ADDENDUM NO. 1

Date: May 20, 2022

Project: **Project #0104-416**

Elder Creek ES Playfield Renovation

SHEET TITLE **EROSION**

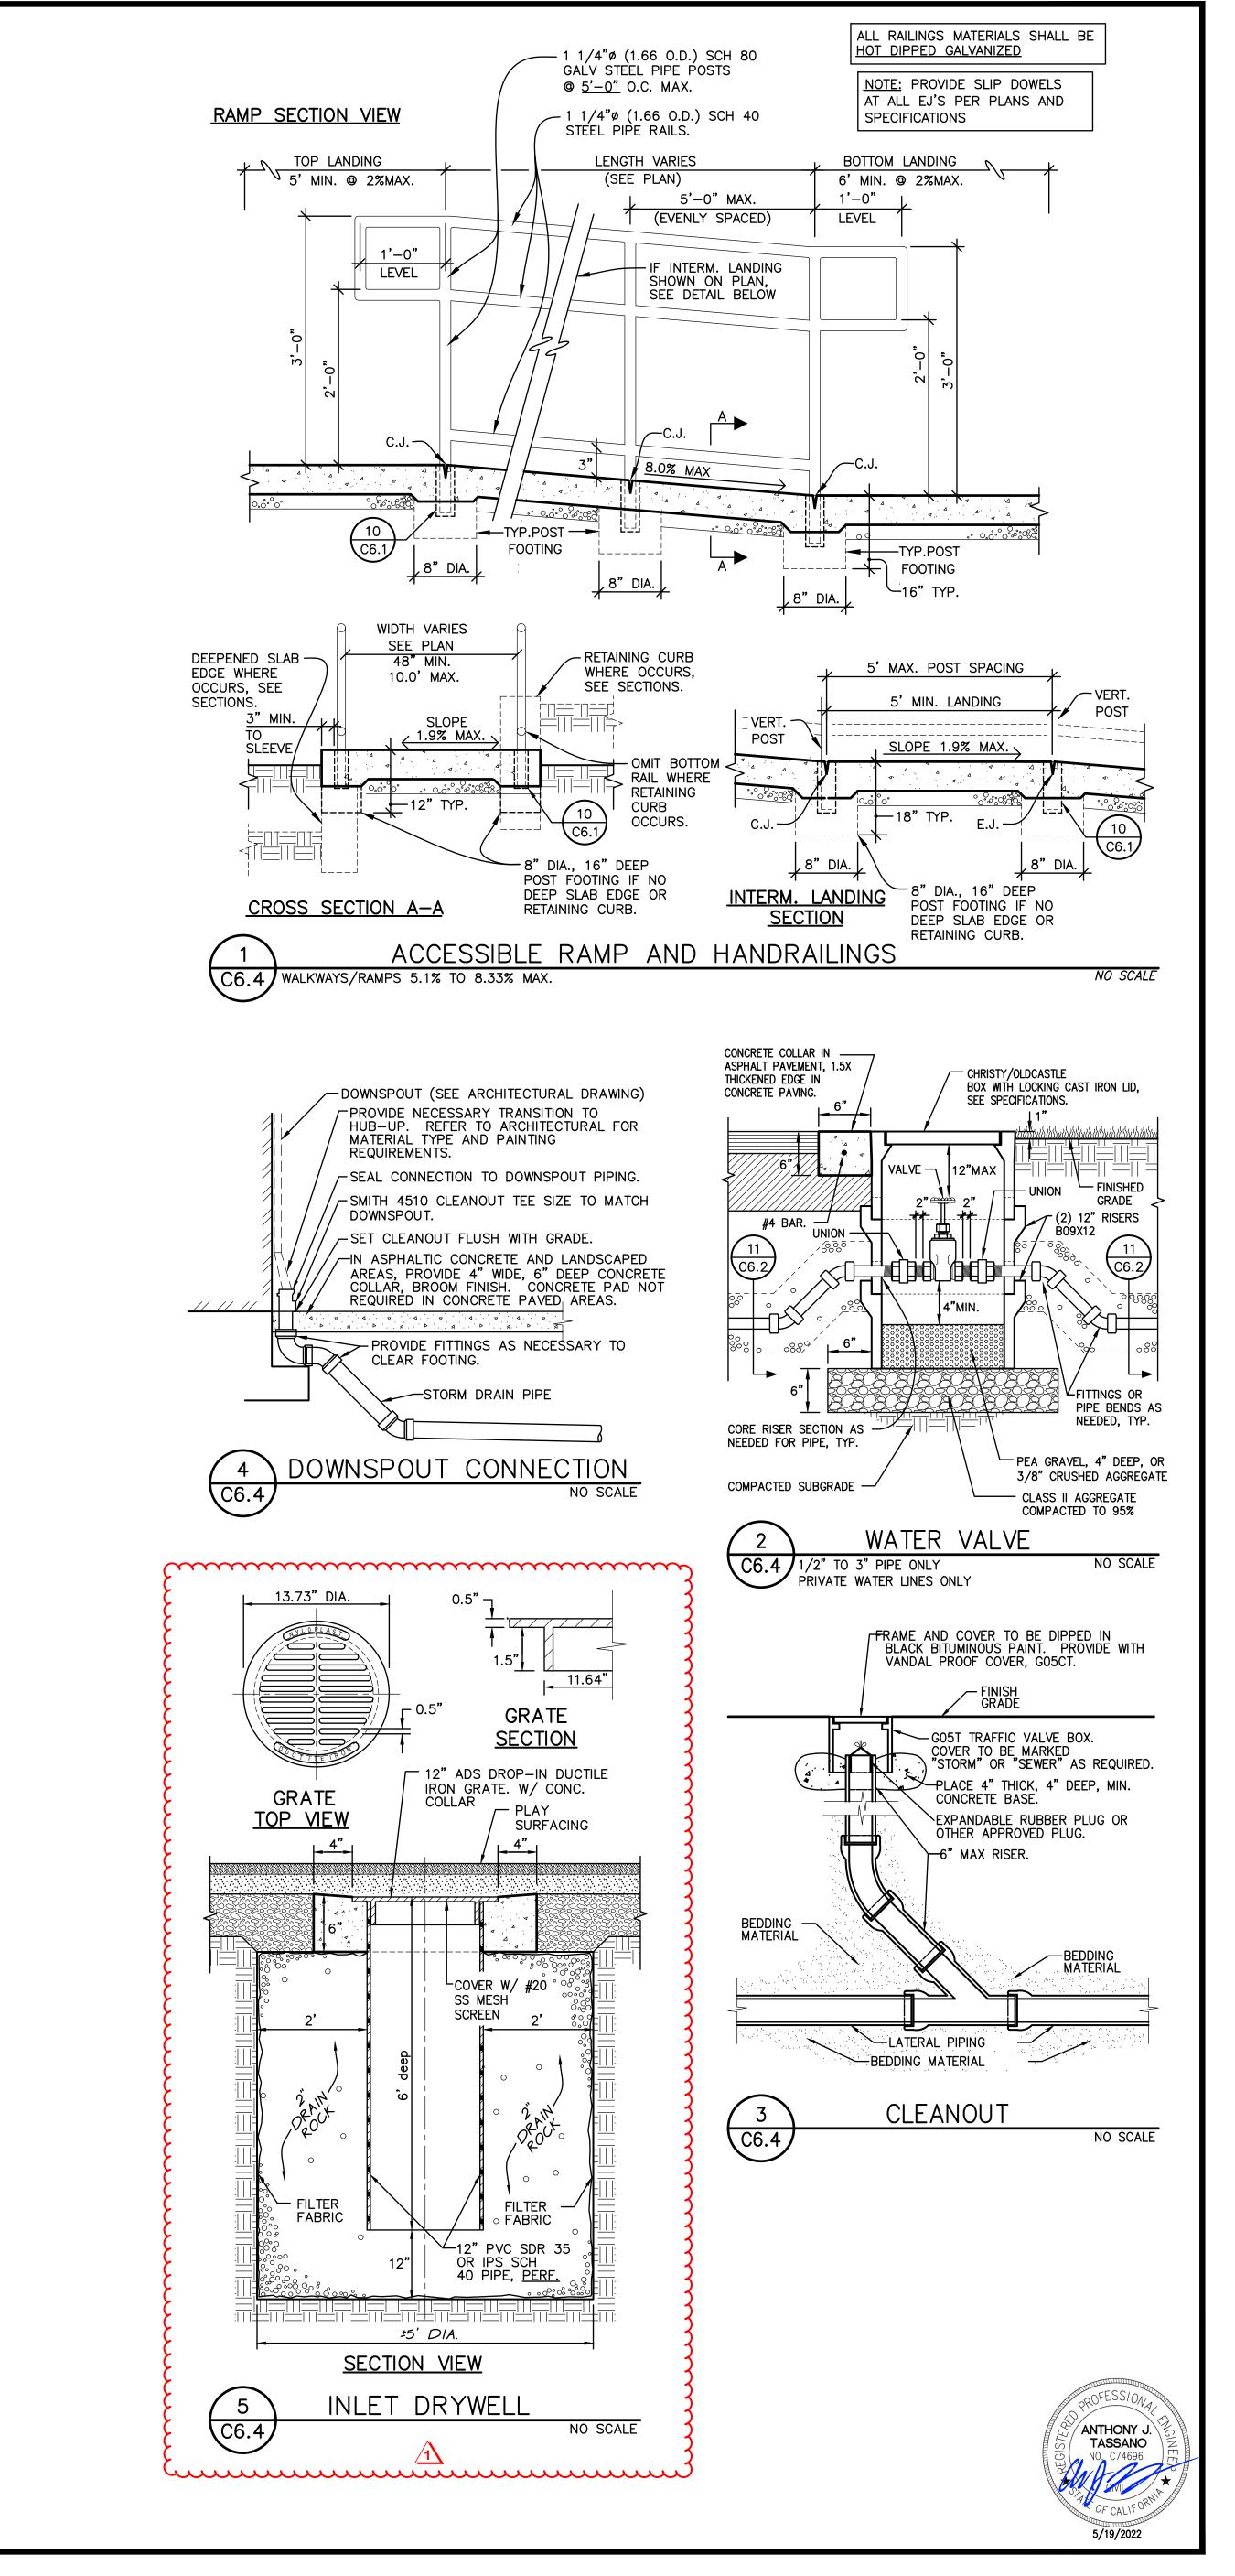
AD1.05 - (Ref) Sheet C5.1: This plan sheet is updated as follows

1. Inlet erosion protection now shown at 6 new drywells per item AD1.04.

/1\ PLAY APPARATUS

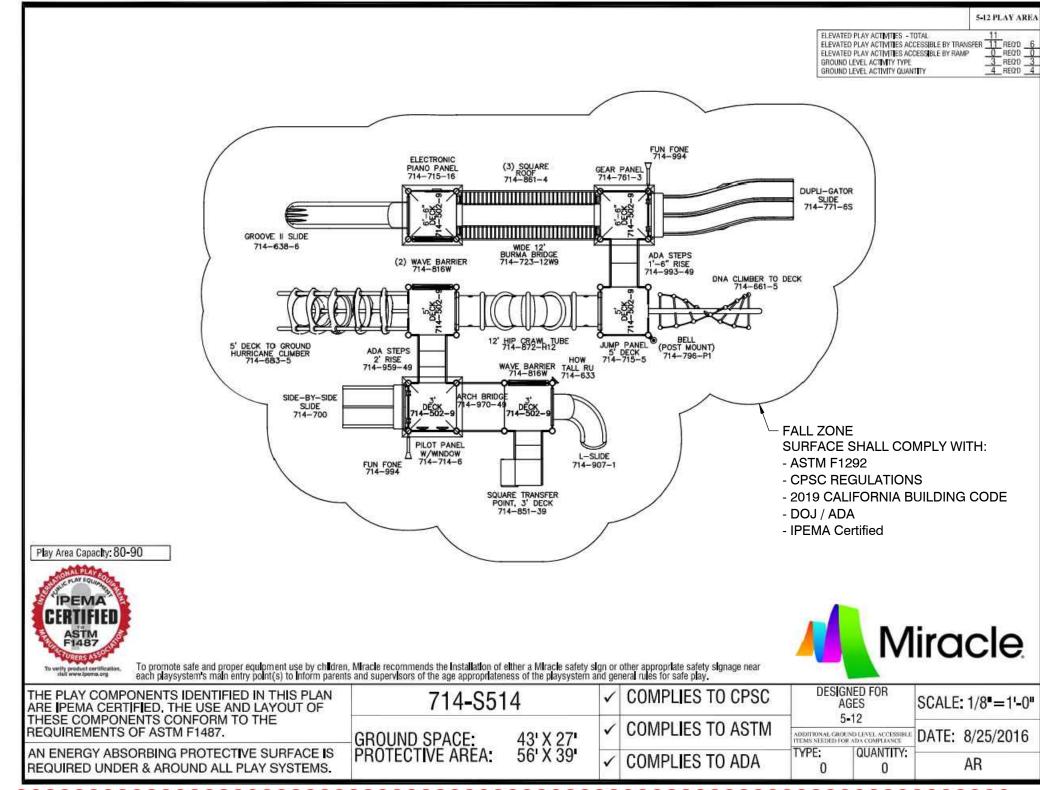
AD1.07 - (Ref) Sheet C7.2: This plan sheet is updated as follows

1. Note added to play apparatus detail as follows: "NOTE: PLAY GROUND EQUIPMENT SHALL COMPLY WITH CBC 11B-240 AND ITS SUB-SECTIONS AS APPLICABLE & 11B-1008. GROUND SURFACE MUST COMPLY WITH 11B-1008.2.6."

NOTE: PLAY GROUND EQUIPMENT SHALL COMPLY WITH CBC 11B-240 AND ITS SUB-SECTIONS AS APPLICABLE & 11B-1008.
